Issue	**1**
Factory ID	**26328**
Date of Issue	**22-Apr-2026**

Fashion & Styles

Structural Safety Inspection Report

Pakistan Accord Initial Safety Inspection Report

Figure 2.1 - Identified location of highly overstressed internal column at basement level of building 01 (area1)

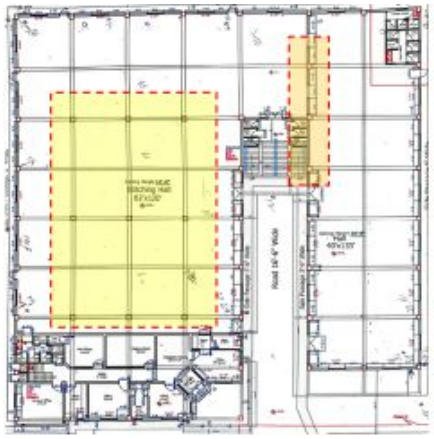
The internal columns of the building 01 are observed to be highly stressed in following areas:

- In area 1 at basement level due to the greater number of storeys(B+G+2), unavailability of concrete data and relatively large grid spacing (12.19x5.89m) in proportion to their section sizes (0.46x0.46m).
- In area 2 at ground level due to the greater number of storeys(G+2), unavailability of concrete data and relatively large grid spacing (11.64x5.94m) in proportion to their section sizes (0.51x0.51m).F-202603-064105

Timeline	Remediation Plan
Immediate CAP-0075133	Verify the thickness and type of floor finishes at all super structural levels. Submit pictorial evidence to Pakistan Accord.
Immediate CAP-0075134	Verify insitu reinforcement by removing cover and confirming no. and diameter of bars and submit results to Pakistan Accord.
Immediate CAP-0075135	Verify in-situ concrete strength for the identified columns either by 100mm dia. cores from at least 4 columns or existing cylinder strength data and submit results to Pakistan Accord.
Immediate CAP-0075136	Factory Engineer to review design, loads and columns stresses in area identified and submit to Pakistan Accord for review.
Immediate CAP-0075138	(1) Appoint a qualified and competent Structural Engineer to carry out DEA on the full building, in accordance with the DEA scope and minimum requirements set out in the Initial Inspection report.
Medium Term CAP-0075139	(2) Submit accurate As-built Drawings showing structure, loading, elements, dimensions, levels, foundations and framing on Plan, Section and Elevation drawings and a report on Engineering tests carried out to justify material strengths and reinforcement content in all key elements studied, to Pakistan Accord for review

Medium Term CAP-0075140	(3) Submit structural engineering assessment with supporting calculations based on the as-built drawing and material strengths along with safe load plans reviewed previously using a model-based design that justifies the safety and serviceability of the building against loading as set out in Building Code of Pakistan.
Medium Term CAP-0075141	(4) Submit proposals for any retrofitting works that may be needed to demonstrate the adequacy of the structure to Pakistan Accord for review.
Longer Term CAP-0075142	(5) Carry out all retrofitting works if needed as proposed and previously reviewed by Pakistan Accord.
Longer Term CAP-0075143	(6) Factory to advise Pakistan Accord when all retrofitting works are complete and make provision for a verification inspection attended by the factory Structural Engineer. Once Pakistan Accord has verified retrofitting works in accordance with previously reviewed proposals, then this item will be complete.

Figure 2.2 - Identified location of craking in boundary wall at ground floor.

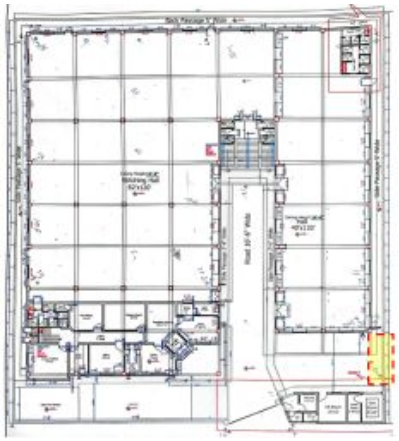
Cracking was observed in the boundary wall located between Building 01 and Gate Office 1. The potential cause can be due to additional imposed load by the steel stair resting directly on wall. F-202603-064125

Timeline	Remediation Plan
Medium Term CAP-0075228	Building Engineer to inspect the wall and confirm the source of the cracking.
Medium Term CAP-0075229	Propose the remedial work and submit to Pakistan Accord for review.
Longer Term CAP-0075230	Implement the required remedial works.

Figure 2.11 - Identified location of lack of edge protection at projection on second and first floor of building 01 (area 2)

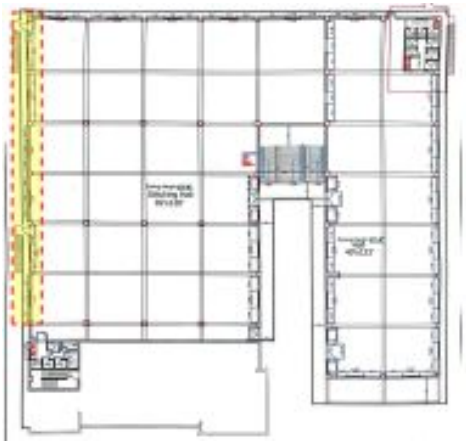
It concerns with lack of edge protection on the roof of building 01 in all three areas (area 1, area2 and area 3), and at the projection at second and first floor in area 2 of building 01, which present a risk of potential injury resulting from slip, trip or fall from roof during the access and maintenance of services – Health & Safety concern. F-202603-064109

Timeline	Remediation Plan
Immediate CAP-0075157	Provide adequate edge protection at the identified locations, and on any other part of the factory with the same issue.
